PLANNING COMMISSION MEETING STAFF REPORT

NAME OF PROJECT: The Village

AGENDA ITEM: Master Plan

Subject: The Village Development – Master Plan Review

LUSTER THE VILLAGE
 OPEN SPACE PLAN

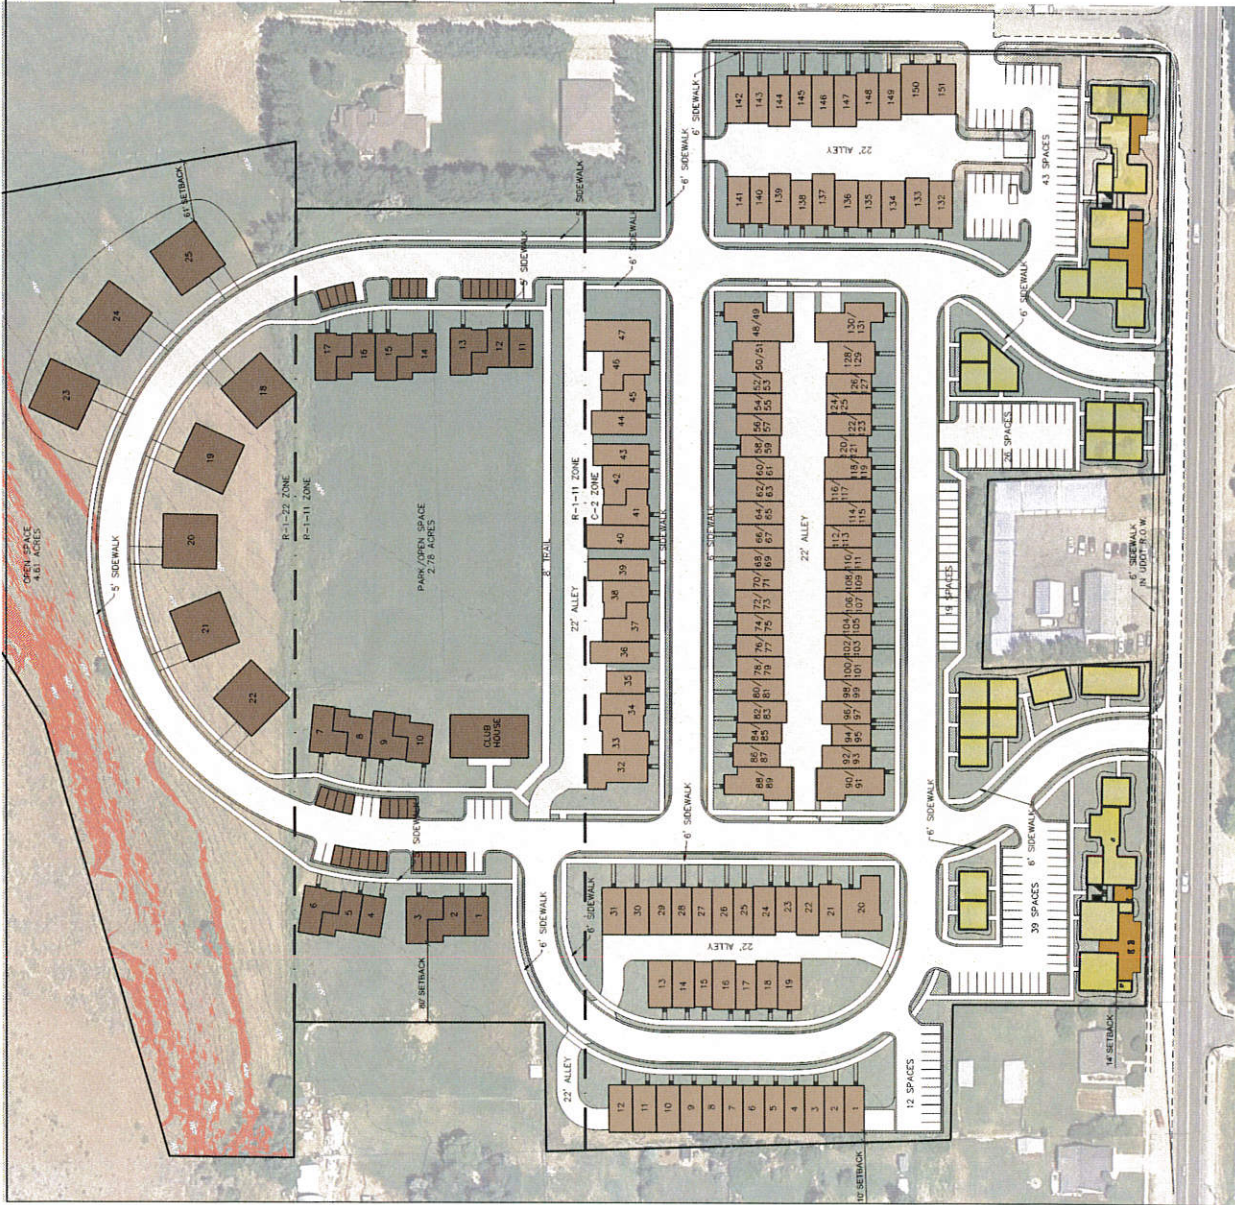
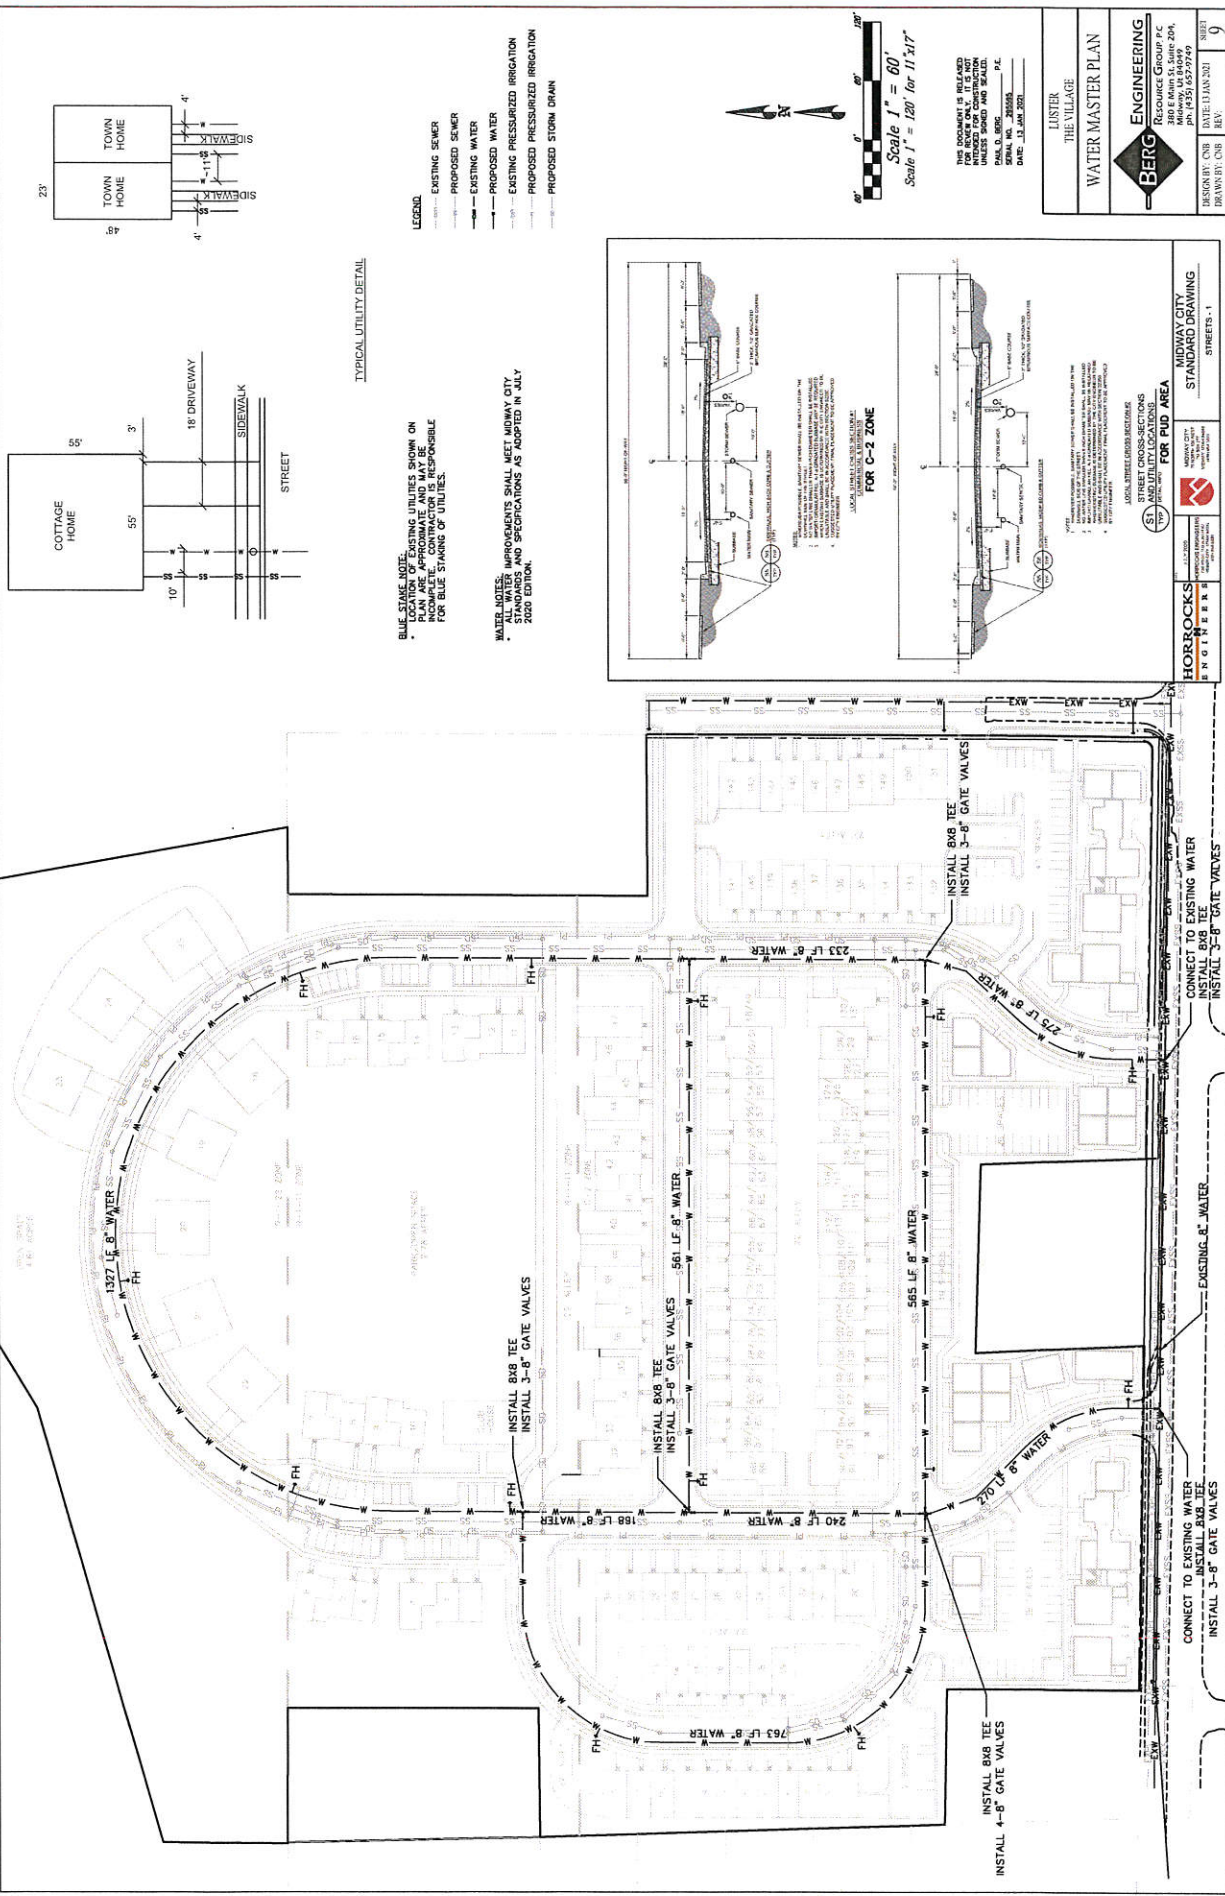
Open Space – The proposal has no required open space except for the area of the PUD where 50% is required. The application indicates that the PUD has 55% open space as presented on the Open Space Plan (please see attached). The code requires that with each phase there is enough open space to comply with the 50% requirement of the code. If phase I has 75% open space, then phase II only needs to have 25% open space if both phases are equal in acreage. Since some of the units included in the PUD are in phase 3, some of the open space currently planned for phase 6 will need to be dedicated as part of phase 3.

1. Open space is dedicated as part of phase 3 to comply with PUD open space requirements.
2. More information must be provided to better analyze the required parking.
3. Four more visitor parking stalls must be provided in the PUD.
4. 20% of the gross square footage must be commercial.
5. The property under 670 East is owned by Chad Thacker and that area is part of the CTM subdivision plat. The City needs documentation that the road will either be developed as a private road with the appropriate easement or that the property will be dedicated to the City so that it will be a public road.
